Regulations Nos. 13 and 13-H (Braking) - Trailer braking

Proposal for amendments to Regulation No. 13 (Heavy vehicle braking)

Submitted by the experts from the European Association of Automotive Suppliers *

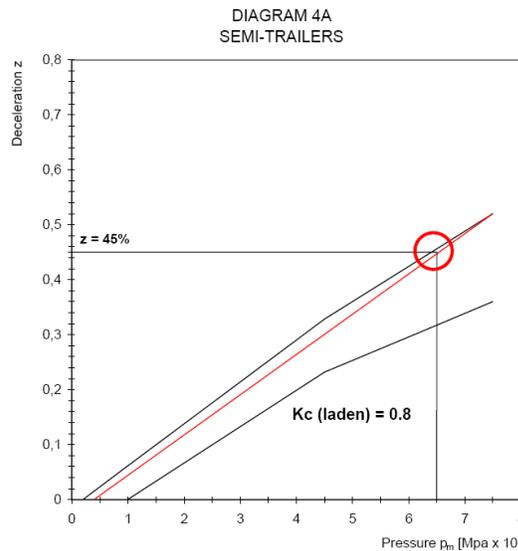
1. The compatibility limits of semi-trailers are set by the modification of diagram 4A in Annex 10 using the correction factors K_c (laden) and K_v (unladen) determined from diagram 4B in Annex 10. The correction factors K_c and K_v take into account the king-pin to axle group distance, the imposed loads on both, and the centre of gravity height.
2. The K_c value is especially significant for high and short semi-trailers. In an extreme case of $K_c = 0.80$, the limit can restrict the maximum deceleration (z) to 45 per cent, which is the minimum required by paragraph 3.1.2.1. of Annex 4. A higher level of deceleration would result in the upper boundary being crossed:

3. In the case of K_c -factors < 0.8 , the upper limit (paragraph 4.1.2.) can be exceeded. By amending the < 0.80 limit to < 0.95 , a higher maximum deceleration is allowed.
4. Historically, maintaining semi-trailer stability under braking was more important than achieving high levels of deceleration. Locking of the brakes on semi-trailer axles results in rear of the trailer swinging-out ("trailer swing"). The introduction of towing vehicle-trailer "compatibility" requirements under Annex 10 began to regulate the relative performance of both parts of a combination, and the subsequent introduction of the

"4.1.2. ~~If the requirements of paragraph 4.1.1. of this annex cannot be satisfied in conjunction with the requirements of paragraph 3.1.2.1. of Annex 4 to this Regulation for semi-trailers with a K_c factor less than 0.80, then the semi-trailer shall meet the minimum~~ **The provision of paragraph 4.1.1. does not have to be fulfilled, if a semi-trailer with a K_c factor less than 0.95 meets at least** the braking performance specified in paragraph 3.1.2.1. of Annex 4 to this Regulation. ~~and be fitted with an anti-lock system complying with Annex 13 to this Regulation, except the compatibility requirement in paragraph 1 of that annex."~~
